# Product/Process Change Notice (PCN)

PCN #: WL-SWTP\_20160318  
Product Affected: WE-SWTP  
158301xxx, 158302xxx, 158563xxx

PCN Date: March 18<sup>th</sup> 2016  
Effective Date: June 18<sup>th</sup> 2016

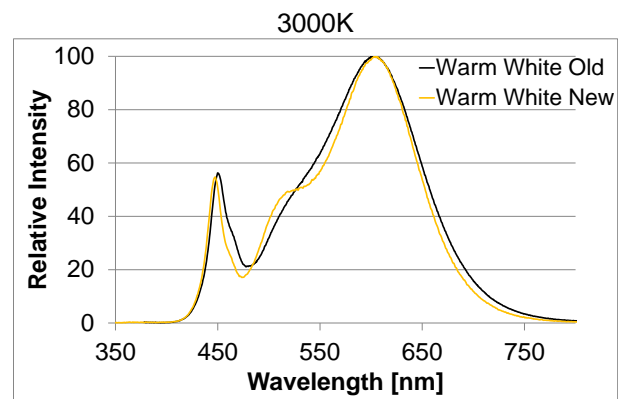
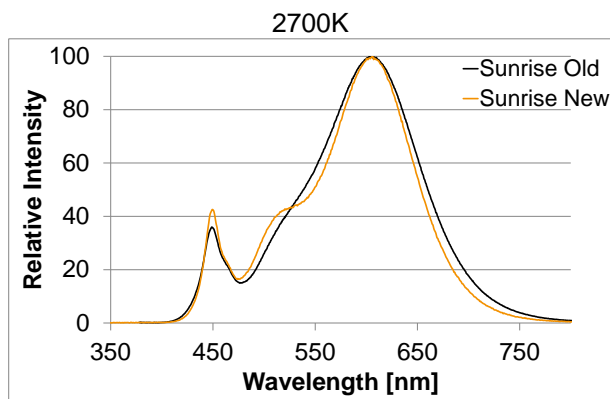
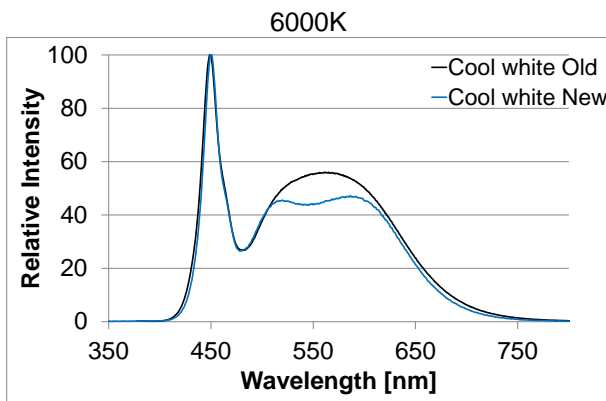
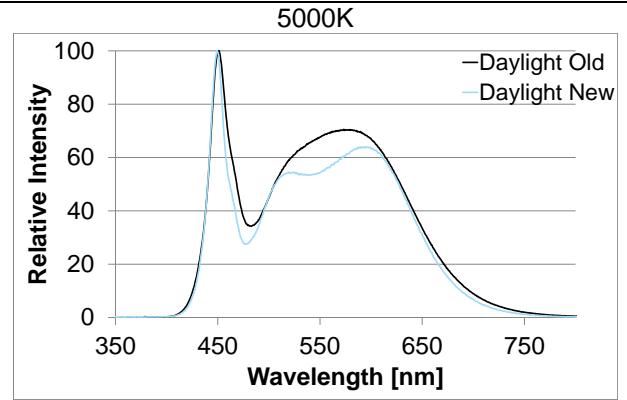
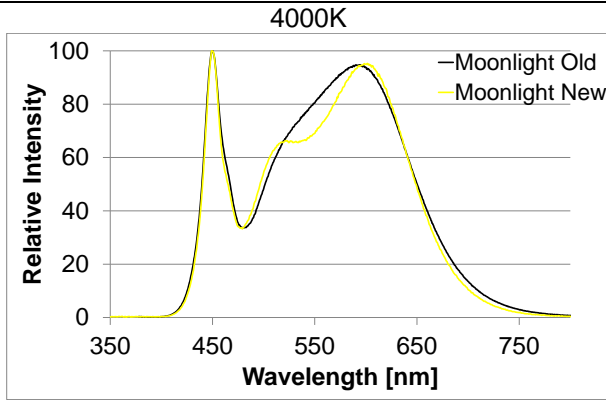
In order to enhance the product applicability, optical parameters have been improved.

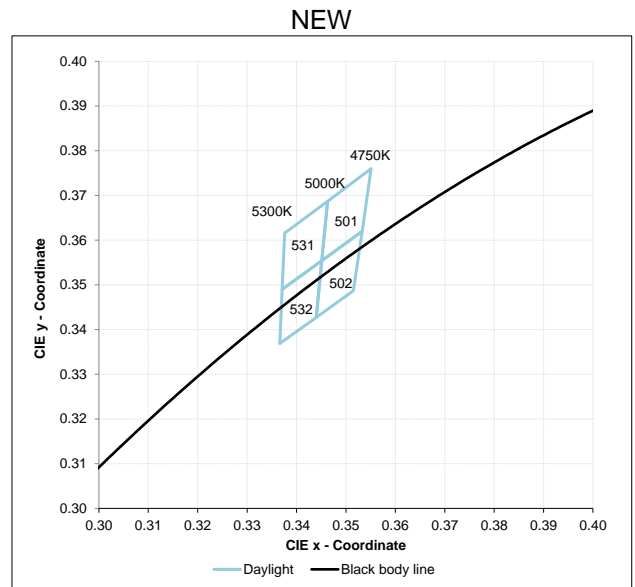
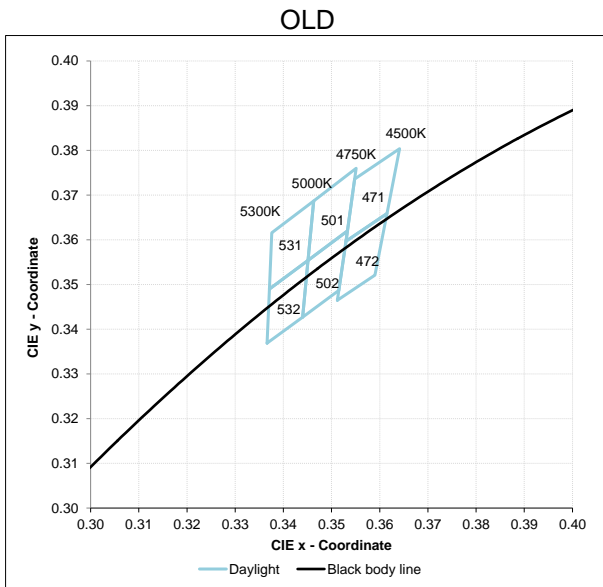
New product have improved optical spectrum and better light quality. The rest of the opto-electrical parameters have been adjusted to the product improvements.

For product series with 5000K - 158302250 and 158563450 binning table is improved trough better light output parameterization.

The Intensity curve vs. current is changed to relative value, for easier estimation of the output light for different currents.
